# Technical Service Bulletin

## 01 MIL on, DTC P030500 stored in ECM

01 19 03 2045909/6 February 12, 2019. Supersedes Technical Service Bulletin Group 01 number 17-34 dated September 1, 2017 for reasons listed below.

Model(s)	Year	VIN Range	Vehicle-Specific Equipment
RS 7, RS 7 performance, and S8 +	2016 - 2017	All	Not Applicable

*Figure 1. Before installation.*

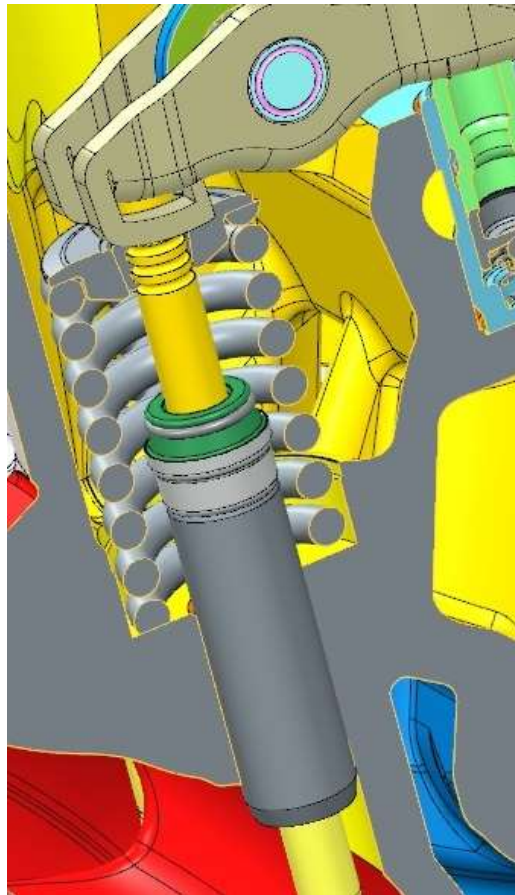
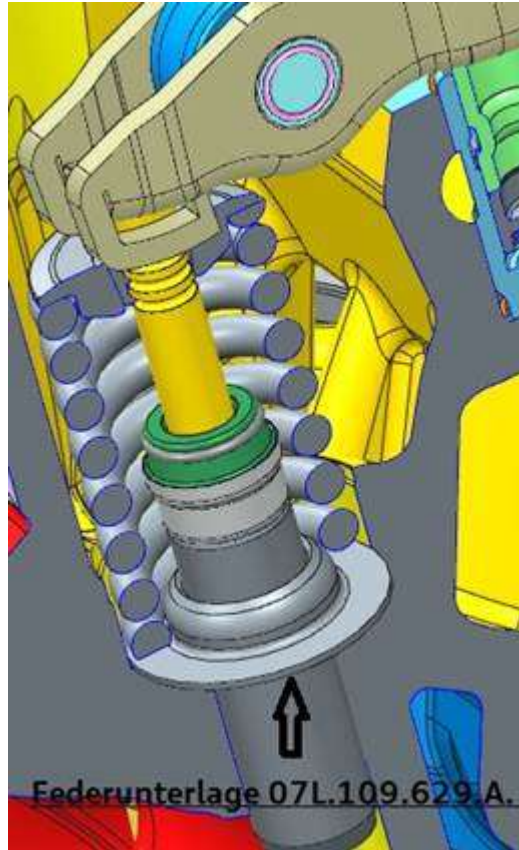
1. Follow all instructions in TSB 2011732: *00 Software Version Management (SVM), operating instructions*.
2. Update the ECM, J623 (address word 0001) using the SVM action code as listed in the table below if necessary. No further repairs are necessary after updating the ECM unless the vehicles returns with the same DTC P030500 with the specific ambient conditions listed above, see Step 3-5.
3. If ECM software is up to date, install spring plates under the exhaust valve springs on Bank 2 (cyl 5-8).
4. Before installation on spring plates (Figure 1).

5. After installation of spring plates (Figure 2).

Figure 2. After the part has been installed.
